**Open Water Peer Review Panel  
Monitoring Plan Recommendations Report:  
Crowley Proposed Dock Upgrades in Kotzebue, Alaska**

The Open Water Peer Review Panel (hereafter, “the panel”) discussed and reviewed the marine mammal monitoring and mitigation plan (4MP) submitted by Crowley Fuels, LLC, (the applicant) for its proposed dock upgrades in Kotzebue, Alaska. Panel members answered the questions below set forth by the National Marine Fisheries Service’s (NMFS) Office of Protected Resources (OPR) and provide the following recommendations. Answers and recommendations are based on the specific questions that were developed using the general monitoring requirements outlined in the Marine Mammal Protection Act (MMPA) implementing regulations and further guidance provided by OPR, which were included in the instruction document and have been copied into this document below the questions.

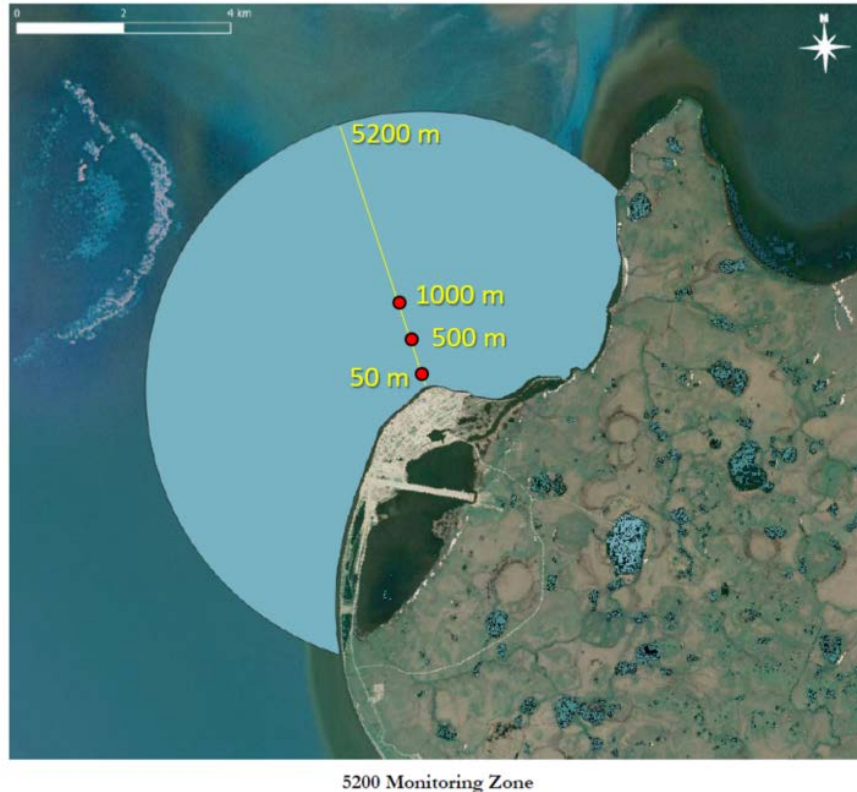
- 1) Sound source verification: At the start of pile installation for each pile type or dimension, the two (or three) units should be deployed in a line perpendicular to shore from the pile driver location. The simplest approach would be to follow a near, medium, and far approach with equidistant mooring distances. For example, the first could be deployed in the near field, at 10 to 50 m from the pile, with the second unit deployed at a farther distance, such as 1,000 m from the pile. If a third buoy is available, this should be placed at a medium distance, such as 500 m, providing received levels at 2 to 3 different distances (Fig. 1). Alternatively, a potentially superior placement of moorings would be achieved following a logarithmic approach to deployment, where distance between moorings represent values that are in an equal ratio, for example 10, 100, 1000 m from the pile driver, as the results will likely provide a better fitting for an exponential regression curve to calculate propagation loss. Distances should be discussed with the manufacturer of the PAM system to make sure the dynamic range and system gain is appropriate for this task (i.e., they might want a lower gain for the closer buoys, and higher gain for the farther units). This configuration should be maintained for at least 60 minutes of noise producing activity, to allow calculating median values from a representative time series. For example, after 1 hour of pile driving, the buoys at 50 and 500 m (or 10 and 100 m for the logarithmic approach) can be moved from their locations to another farther away, closer to the edge of the Level B harassment zone, to start the monitoring configuration.

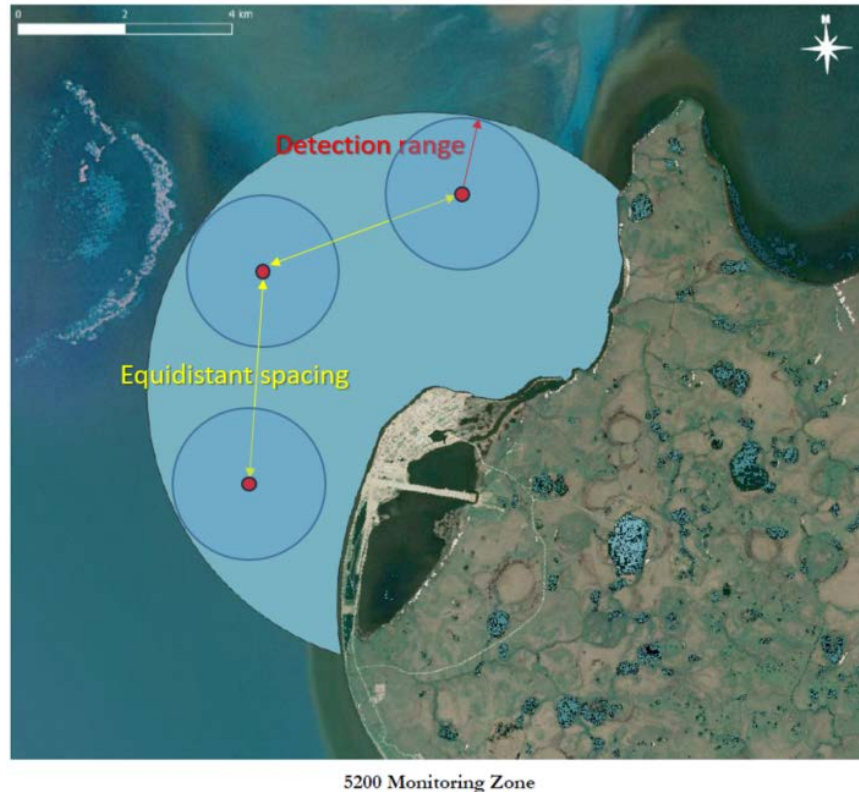
- 2) Detection of marine mammals in the far field: This monitoring configuration is designed to maximize detection of marine mammals entering the Level B harassment zone, in those portions of the zone too far for observers to see. Ideally, the two (or preferably three) buoys should be placed at equidistant intervals from each other to maximize and homogeneously distribute coverage, and all at the same distance to the edge of the Level B harassment zone. In order to assume that each acoustic detection is a take, the acoustic detection range from the target marine mammal species should be considered (see Table 1), and that range should be used to place the buoys inside the Level B harassment zone at that specific distance from the edge of the Level B harassment zone. For example, if the detection range for beluga whale vocalizations is estimated to be 3.3 km, all buoys should be placed 3.3 km from the offshore border of the Level B harassment zone (Figure 2). For multiple species, the panel recommends using the farthest detection range for buoy placement.

Figure 3: Example of monitoring configuration for real-time PAM. Three moorings (red dots) placed at equidistant intervals from each other, and with their respective detection ranges of ~3.3 km (blue areas) corresponding to their distance to the edge of the 3,500 m Level B harassment zone.

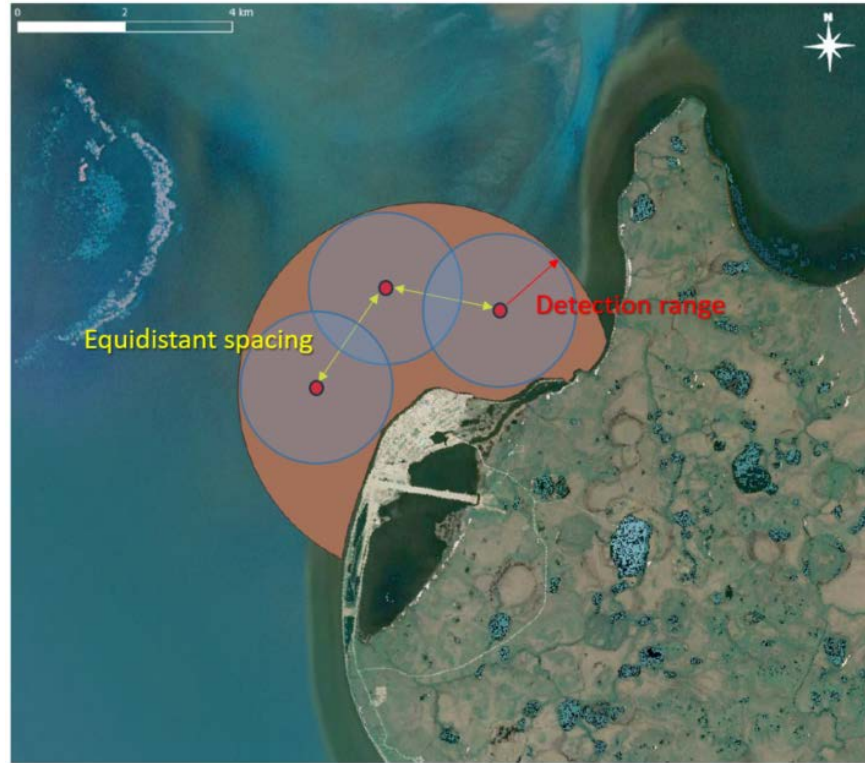
The monitoring configuration should be revised for every change in Level B harassment zone. For example, if the activity switches from a 5,200 m (vibrating sheer piles) to a 3,500 m Level B harassment zone (temporary template pile), the buoys should be moved to their respective new locations closer to the piling activity to maintain their distances to the edge of the newer and smaller Level B harassment zone (Fig 3).
